REMARKS

Docket No.: FUJG 17.913 (100794-11532)

F1G. 2

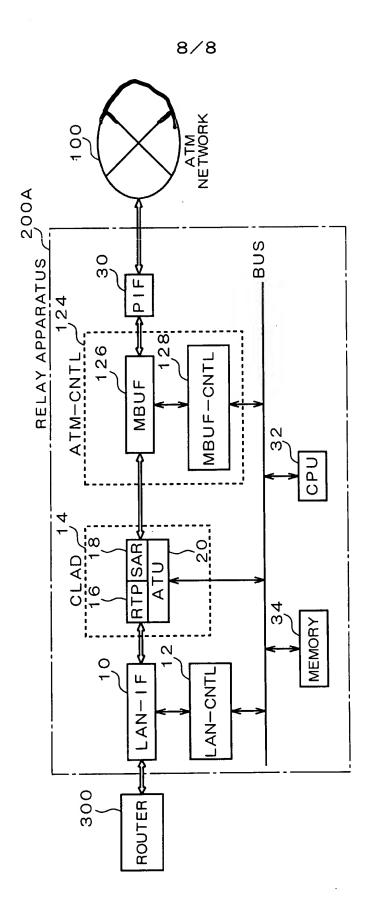
Figures 2 and 10 of the drawing are objected to for failing to fully illustrate the element identified by reference index 100. Applicant proposes associated revisions to Figures 2 and 10 to address this objection as indicated in the attached drawing replacement pages, provided in both marked-up and clean copies. Applicants respectfully request that the proposed revisions be accepted, and that the objections be withdrawn.
